Access Compliance Report Public Rights-of-Way (Curb Ramps)

Main Street: VAN_BUREN_ST		Cross Street: VAN_BUREN_ST		Location:	W
ADA ID: RPRK220207122845	Ramp Type: Type 4 - Parallel	Initial Pass/Fail: Fail	Overall Compliance: No	Severity Score:	16
Codes/Mitigation Info/Possible Solution			Field Measurements/Component Compliance

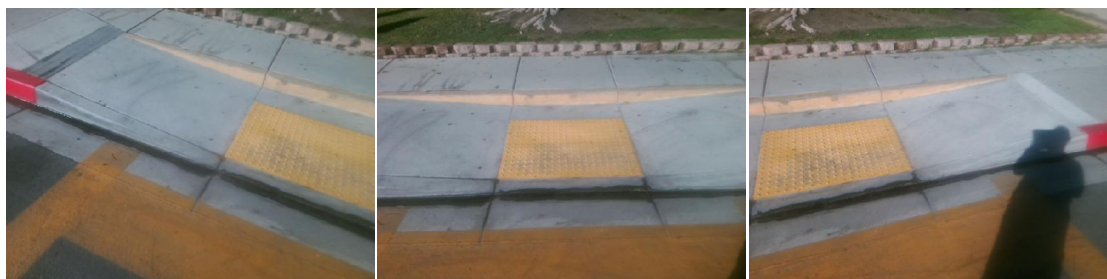
R304.3.2, R304.5.3, STD 1115

Compliance	Description	Data	Compliance	Description	Data
N/A	Ramp Length LT (in)	70	N/A	Ramp Length RT (in)	73
Yes	Ramp Width LT (in)	50	Yes	Ramp Width RT (in)	50
No	Ramp Run Slope LT (%)	9.2	Yes	Ramp Run Slope RT (%)	7.4
No	Ramp Cross Slope LT (%)	2.2	No	Ramp Cross Slope RT (%)	2.3
N/A	Landing Present	N/A	N/A	DWS Provided	N/A
N/A	Landing Length (in)	N/A	N/A	DWS Contrast	N/A
N/A	Landing Width (in)	N/A	N/A	DWS Length (in)	N/A
N/A	Landing Run Slope (%)	N/A	N/A	DWS Full Width	N/A
N/A	Landing Cross Slope (%)	N/A		DWS Offset Type	N/A
N/A	Landing Movement Obstructed?	N/A	N/A	DWS Offset Left (in)	N/A
	Landing Movement Type	N/A	N/A	DWS Offset Right (in)	N/A
N/A	Landing Shared	N/A			
N/A	Clear Space	N/A			
N/A	Clear Space To Crosswalk (in)	N/A			
N/A	Marked Crosswalk 1	Yes	N/A	Marked Crosswalk 2	N/A
	Crossing 1 Direction	E		Crossing 2 Direction	N/A
	Marked Crosswalk 1 Width (in)	144		Marked Crosswalk 2 Width (in)	N/A

Remove & Replace Entire Ramp.
